WATER RESOURCES DEPARTMENT MEMORANDUM

GW Application G-15096

Applicant: Michael Skinner

Proposed Use: <u>Domestic/Mobile Home Park</u>

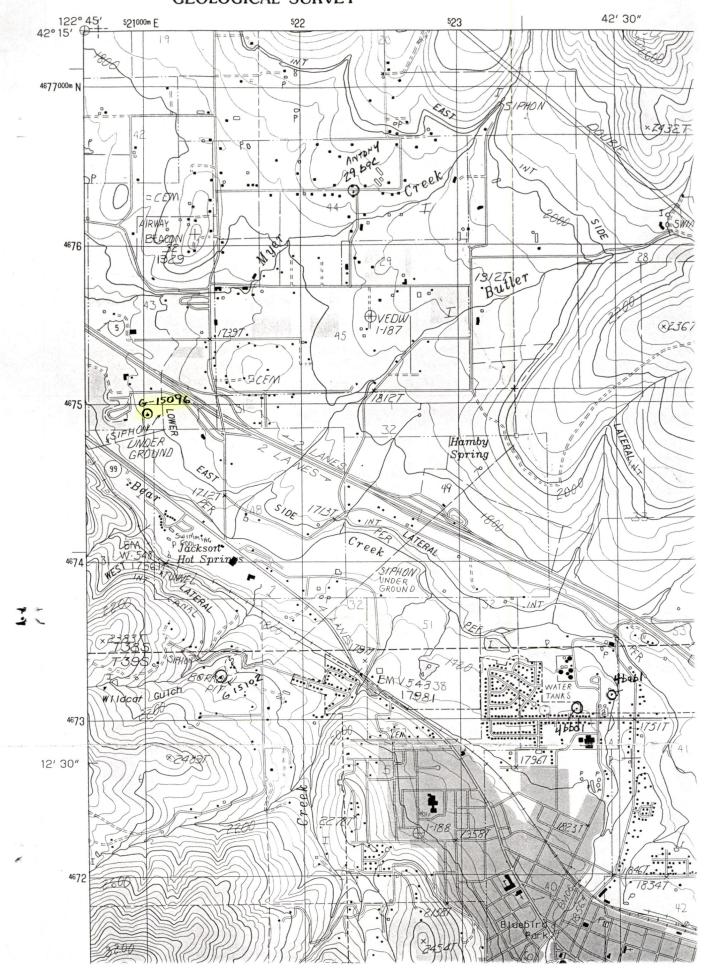
The well log (JACK 20010) describes surficial deposits to 20 ft and yellow sandstone to 24 ft. Grey/black "basalt" is encountered from 24 to 115 ft. As this well is located on the western margin of the Bear Cr Valley it is likely the well has penetrated a thin sandstone unit of the Hornbrook FM. and is developed into the underlying hard rock of the metamorphosed Applegate Gp.

The bedrock formation is indirectly connected to surface water so the potential for substantial interference is minimized. No records in the county file indicating active or historical well interference complaints. The watermaster for Jackson County was contacted but had no concerns for the small additional development in this area.

There is a problem with the current well construction. The well has an inadequate well seal (bentonite to 24 ft in 1964). The well should have new casing and seal extended to at least 29 ft (five ft into the metamorphic "basalt"). Under current construction this well constitutes a health threat to the residents of this mobile home park.

Recommendations: Apply well interference condition and requirement for well reconstruction.
